Re: Southern California Edison's Comments to the Draft Environmental Impact Report/Environmental Impact Statement for the West of Devers Upgrade Project

Southern California Edison's West of Devers Upgrade Project
Draft Environmental Impact Report / Environmental Impact Statement Comment Table
California SCH #2014051041 BLM/CA/PL-2015/012+1793 DOI-BLM-CA-060-0015-0021

Figure B-16
**Proposed Staging
 Yard Locations**

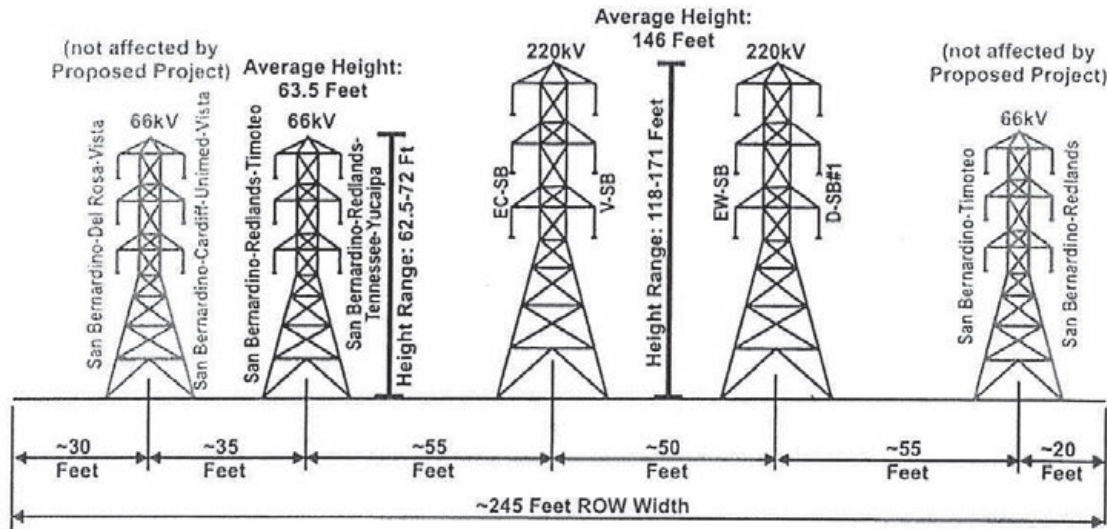
SCE has included an additional Material Staging Yard, due to the potential for any one of the yards listed in the West of Devers Upgrade DEIR Section B Project Description Table B-5 to be occupied and unavailable prior to SCE commencing with construction. SCE has also updated Figure B-16 to include the additional yard. The environmental analysis of this additional yard, as well as SCE’s conclusion that the addition of this yard would not result in any additional impacts beyond those already described in the DEIR/DEIS, is described below:

Figure B-2b
 Existing and Proposed
 Corridor Profile - Segment 1

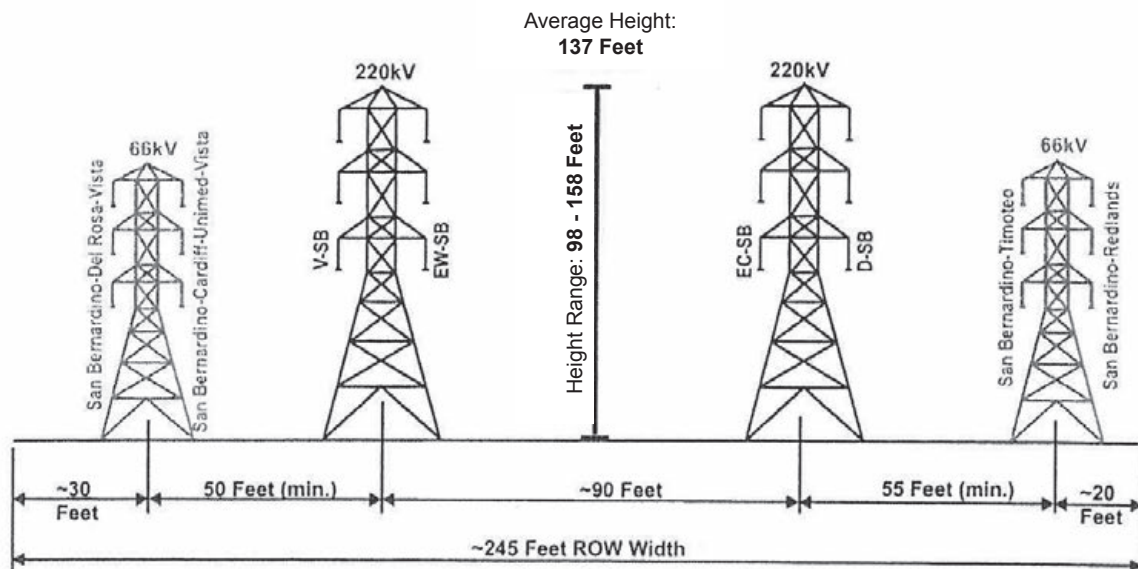
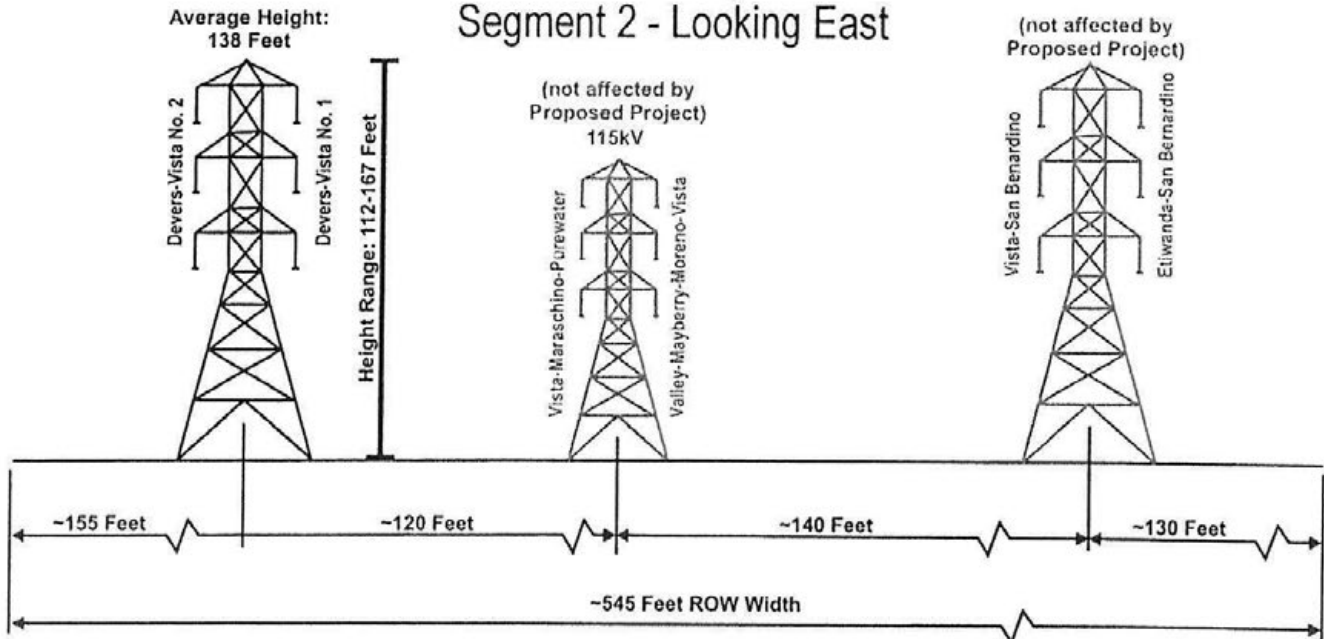
B-77	<p>Figure B-2b</p>	<p>Please see attached file “WODUP_Figure B-2b_Rev.pdf” updating Figure B-2b.</p>
B-105	<p>Figure B-10</p>	<p>Please see attached file “WODUP_Figure B-10_Rev.pdf” updating Figure B-10.</p>
B-125	<p>Location 2: Removal of 12kV and Relocation on the New 66kV Structures.</p>	<p>Please remove location 2 from the map and legend, there is no overhead 12kV on Nevada St from Lugonia Ave to Almond Ave.</p> <p>Location 2: Removal of 12kV and Relocation on the New 66kV Structures.</p>

Figure B-10
**Typical 220 kV
 Transmission Structures**

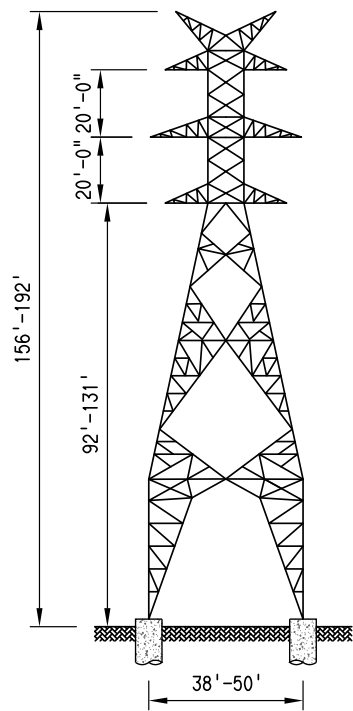
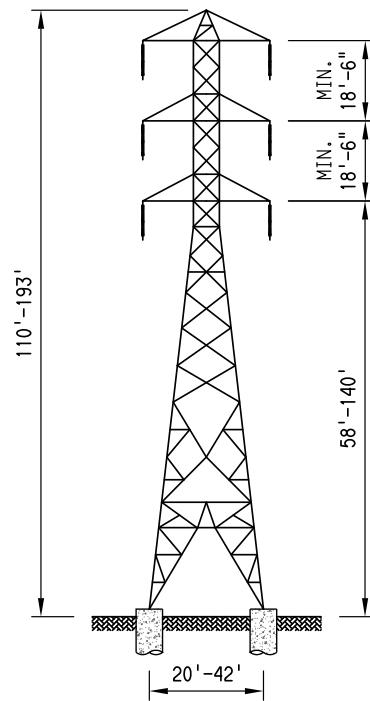
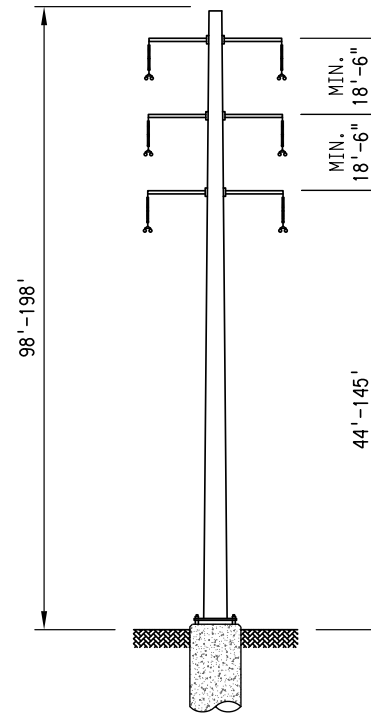
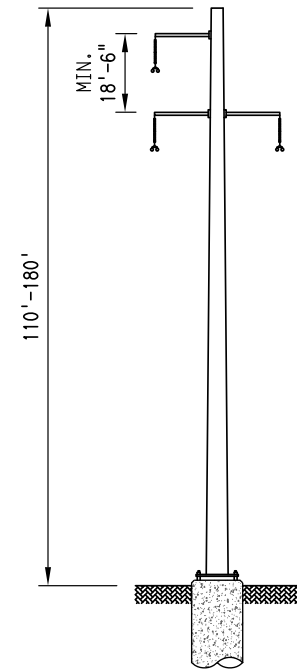
SCE's comments to the Visual Resources section of the DEIR/DEIS indicated that Figure D-18-25B improperly simulates the installation of double-circuit 220kV TSPs (with a typical as shown in Figure B-10), instead of the correct use of single-circuit 66 kV wood poles (with typical as shown in Figure B-14b). If this simulation had incorporated the correct structure type, it would show that the Proposed Project creates a similar visual impact as the "single, wood-pole utility lines along Orange Avenue and a portion of Iowa Street" and the "...vertical street light poles and a more distant communication tower." (See DEIR page D.18-24, KOP-18, Visual Quality.), therefore the significant impact would not warrant the need for the underground alternative as there would be no impact to mitigate. As such the comparison of this underground alternative to the Proposed Project, as seen in Table G-3, indicates that if not for the incorrect conclusion that this alternative was preferred for visual the Proposed Project is preferred for all other resource areas and, therefore, this alternative should be deleted from further consideration and/or Table G-2 should incorporate the following revisions.
